Injection Depth Waiver Evaluation for Geologic Sequestration

Director's Report to the Regional Administrator

Permit Number: CO62455-12770

Front Range Storage Complex

Figure 5. Site-specific confining units and proposed injection interval at the Front Range 1-1 well, including measured depths (MD) along the deviated well path, true vertical depths (TVD), and lithology (modified from CSS, 2024b, Figure I.1.4-2).

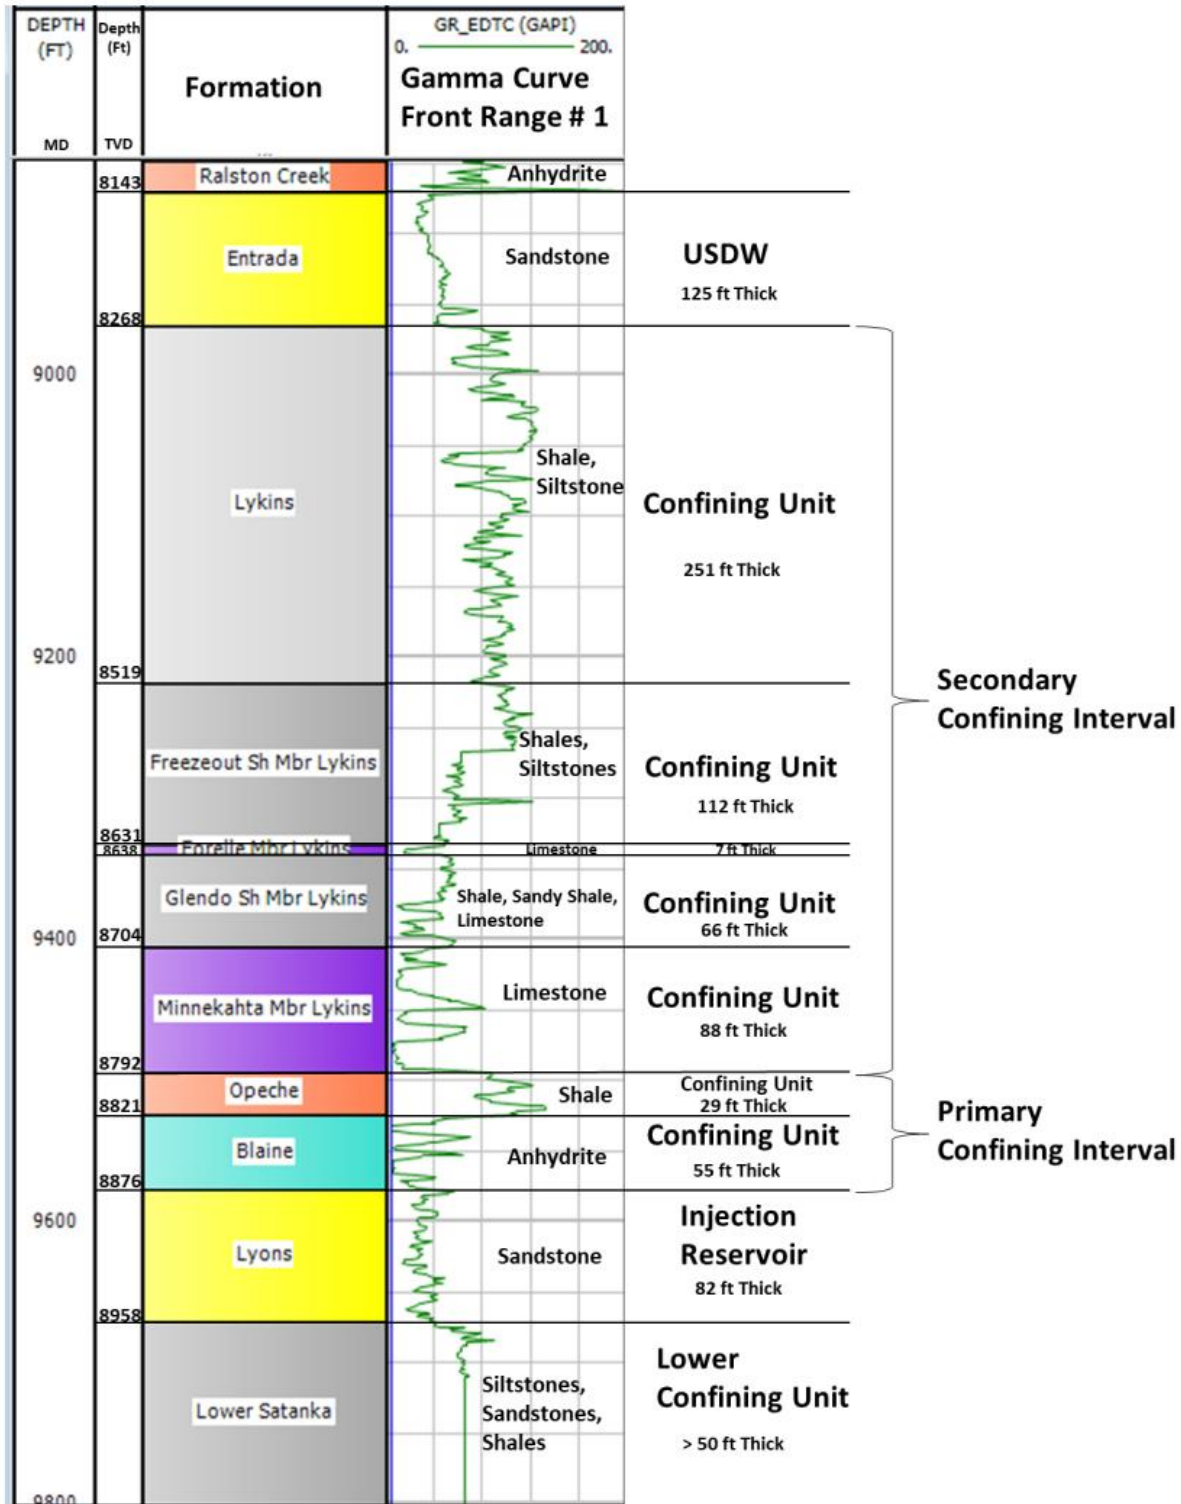
The upper confining zone consists of the Opeche Shale and Blaine Evaporite, which are members of the Lykins Formation (Figure 5).

Opeche Shale: This unit is characterized by predominantly brownish-red claystone with interbeds of gypsum, sandstone, and sandy shales. It is 29 feet thick at the Front Range 1-1 well with 95% of the formation consisting of shale that exhibits a clay content of approximately 64%. The remaining 5% is composed of thin intervals of dolomite, anhydrite, and siltstone. Porosity measured in two core specimens of the Opeche was 3.23 and 7.68%. These porosity values represent total porosities that include clay-bound water, not effective porosities.

Blaine Evaporite: The Blaine Evaporite directly overlies the Lyons Sandstone and is composed of thick beds of gypsum/anhydrite, alternating with shale and thin dolostones. At the Front Range 1-1 well, the Blaine is 55 feet thick with 48 feet (88%) composed of anhydrite. The remaining 7 feet contain thin mudstone/shale, siltstones, and dolomite. Porosity measured in core specimens of the Blaine ranged from 0.67% to 3.2%. A thin-section photomicrograph of anhydrite from the Blaine indicated a porosity of 1.04% and permeability of 3.21 millidarcies (mD).

Owl Canyon Formation (Lower Satanka): The Owl Canyon Formation, part of The Lower Satanka Group is the underlying confining unit beneath the Lyons Sandstone. The formation generally is characterized by a series of interbedded siltstones, shales, and sandstones. The Lower Satanka Formation was not fully penetrated by the Front Range 1-1 well. Therefore, its exact thickness at the well is unknown. However, its thickness at the Front Range 2-1 deep-zone monitoring well, which was drilled to the Ingleside Formation about 1.2 miles northwest of the Front Range 1-1 bottomhole location, was approximately 231 feet. Based on testing of core specimens collected in the upper 50 feet of the formation, the Lower Satanka has porosity ranging from 1.5 to 5.29% with an average of 2.62% and Klinkenberg permeability ranging from 0.0007 to 0.005 mD with an average of 0.0012 mD.

The thickness and low porosity and permeability of the upper and lower confining zones indicate they are effective seals with the ability to prevent migration of fluids, including CO₂, upward or downward out of the Lyons reservoir. In addition, mercury injection capillary pressure (MICP) testing of core specimens indicates that CO₂ column heights of 27,239 feet for the Blaine and 1,150 feet for the Lower Satanka can be sufficiently supported in the Lyons before leakage would occur. These large positive column heights provide further support that the Blaine and Lower Satanka are suitable confining zones for the FRSC. Additional evidence for the integrity of the upper and lower confining zones is provided by differences in formation pore pressures and TDS concentrations (Table 1) among the Lyons Sandstone injection zone, the lowermost USDW overlying the Lyons (Entrada Sandstone), and the underlying Ingleside USDW, suggesting the formations are not hydraulically connected.

Lyons Sandstone: The Lyons Sandstone injection reservoir, 82 feet thick at the Front Range 1-1 site (Figure 5), is described as a fine-grained, quartzose sandstone consisting of about 70% quartz with minor amounts of potassium, plagioclase, and anhydrite. It has porosity ranging from 3.6 to 15% with an average of 7.8%. The formation’s permeability ranges from 0.13 to 19 mD with an average of 3.3 mD. These reservoir values indicate that the formation’s suitability to sequester carbon dioxide. The Lyons Formation exhibited a total dissolved solids concentration (TDS) of 34,076 mg/L at the Front Range 1-1 well, and the formation has a regional average value of 38,105 mg/L, which characterizes it as a non-USDW.

Figure 6B. Geologic cross sections showing north to south (N-S) and west to east (W-E) lateral continuity of strata across the area of the Front Range Storage Complex. Datum is top of the Lyons Formation (modified from CSS, 2024b, Figure I.1.4-4 and I.1.4-5).

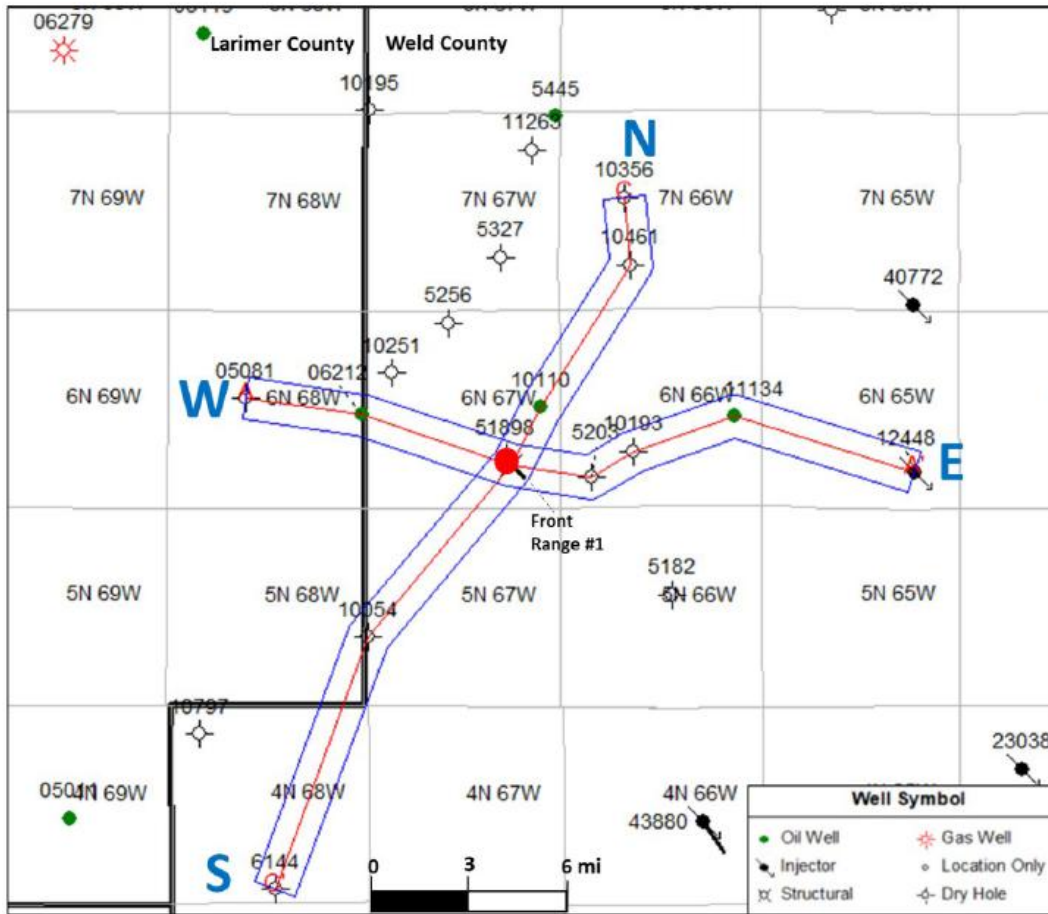
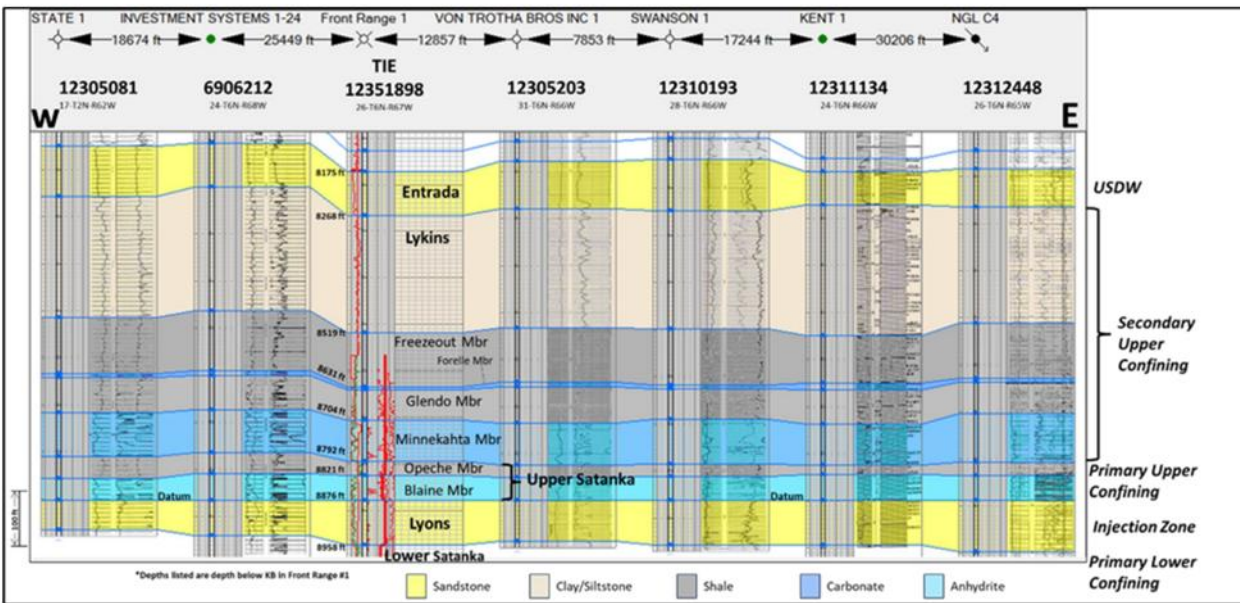
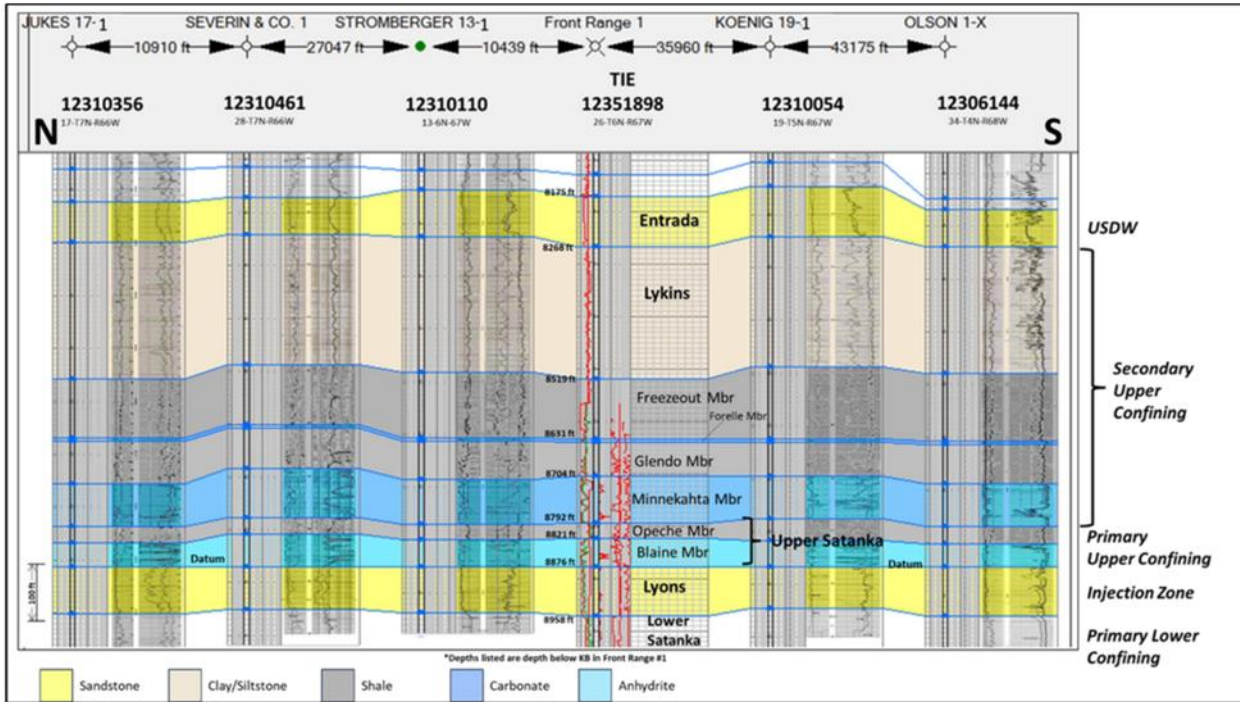
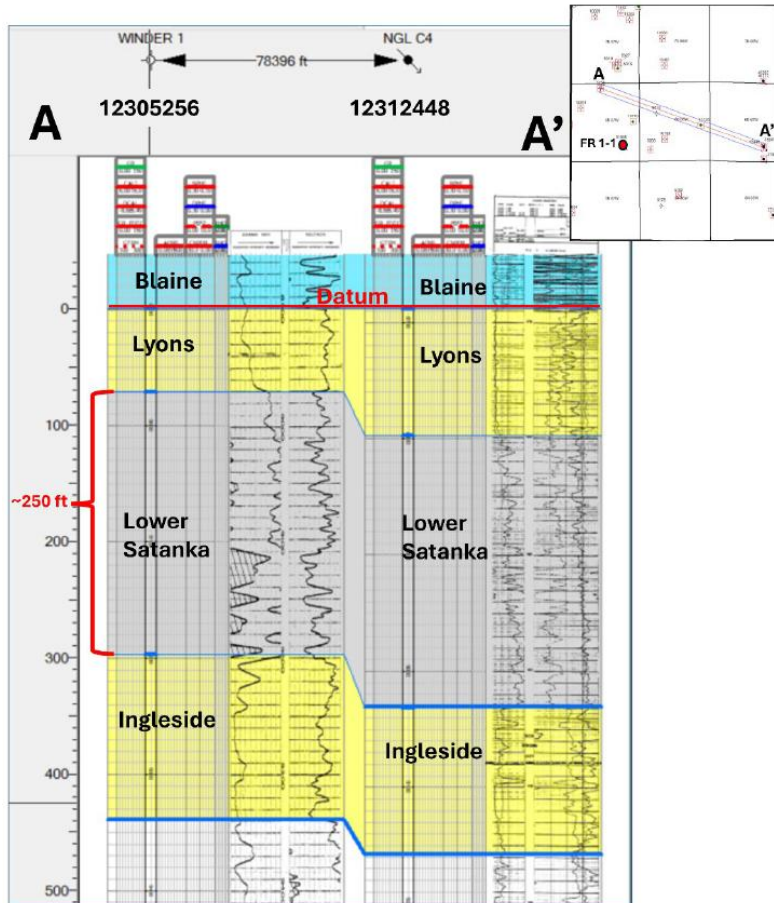
The injection zone and upper and lower confining zones have sufficient lateral extent to contain the injected carbon dioxide stream and displaced formation fluids. CSS submitted geologic cross-sections

(Figures 6a–c) through the area of the Front Range 1-1 well that demonstrate continuity of the injection zone and the upper and lower confining zones as required at 40 CFR § 146.95(a)(1).

Figure 7. Composite 2D seismic line across the area of review for the Front Range 1-1 well (CSS, 2024b, Figure I.1.4-6).

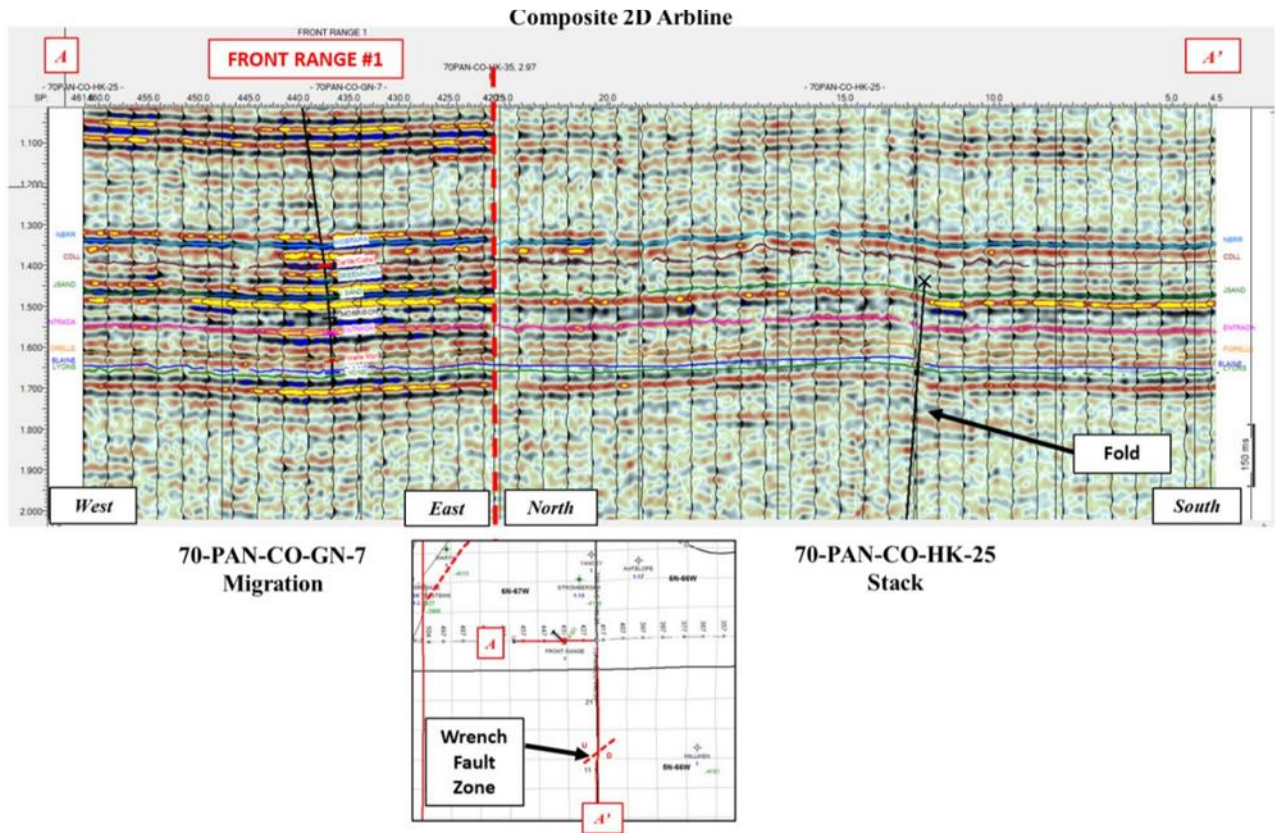
Faulting in the region of the FRSC is sparse and well documented. Results of a seismic survey (Figure 7) further demonstrate that the injection zone and confining zone are laterally continuous across the area of review (AOR), which is the region surrounding the proposed well where USDWs may be endangered by the injection activity, and that no faults are present that would allow CO₂ migration out of the Lyons injection zone. A single wrench fault was identified 4 miles south of the project area that shows basement offset, but the fault propagates upward into a fold that does not appear to offset sedimentary strata.

Figure 8. Diagram showing fracture clusters detected by 3D Far Field log analysis in the FR 1-1 well (modified from CSS, 2024b, Figure I.1.4-23).

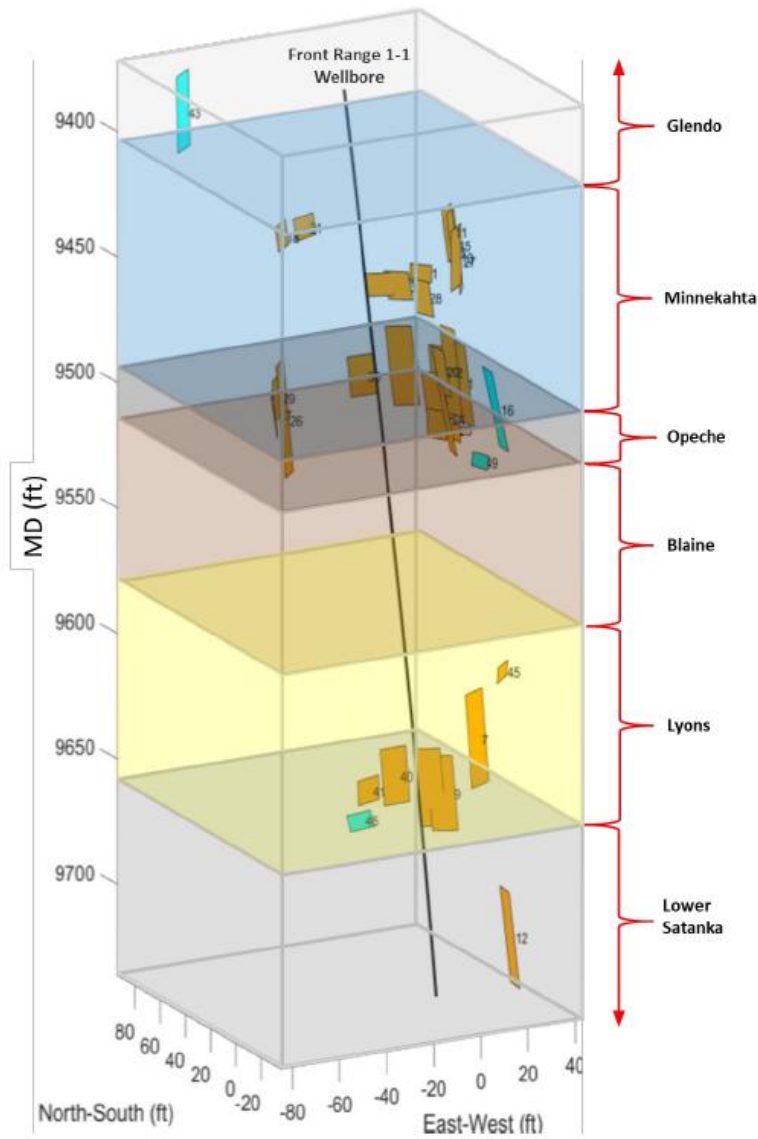
Natural fractures were identified within the Lyons injection zone, the Opeche Shale Member of the Lykins Formation, and the Lower Satanka Formation by 3D far-field analysis of a sonic scanner

log (Figure 8). However, the fractures appear to be isolated and do not connect through the upper or lower confining zones. Thus, transmissive faults and fractures that would provide a conduit for CO₂ leakage out of the injection zone do not appear to be present within the AOR.

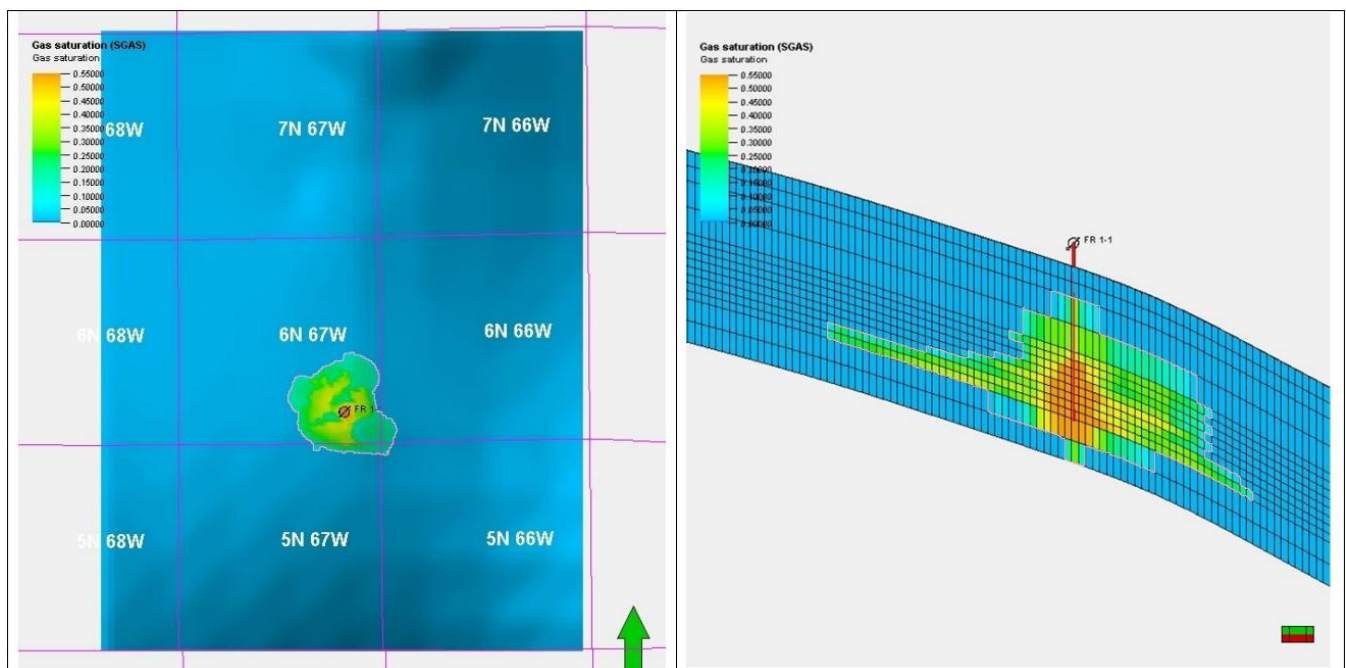
With a thickness of 82 feet, average porosity of 7.8%, and average permeability of 3.3 mD, the Lyons Sandstone at the FRSC has sufficient capacity for the planned injection volume of 1.54 million metric tons to be injected over 12 years. Natural fractures present within the Lyons likely will increase the formation's permeability and overall injectivity. Carbon Storage Solutions conducted computational modeling as a requirement of the Class VI permit application process (§146.84(c)). The model incorporates all the reservoir properties from logging, coring, analysis, and injection testing and was used to delineate the AOR for the Front Range 1-1 well based on the maximum lateral extent of 1) the pressure perturbation capable of mobilizing fluids that could endanger USDWs; and 2) the CO₂ plume over the lifetime of the project, including the post-injection site care period. The modeling results also demonstrate that USDWs above and below the injection zone will not be endangered as a result of fluid movement (40 CFR § 146.95(a)(3)). Figure 9 shows the simulated maximum areal extent (6.4 square miles) of the plume and a cross section of the approximate maximum vertical and lateral extents of the plume in year 32 at the end of the post-injection site care period. The model shows the injected CO₂ remains in the Lyons Sandstone and that it is concentrated near the Front Range 1-1.
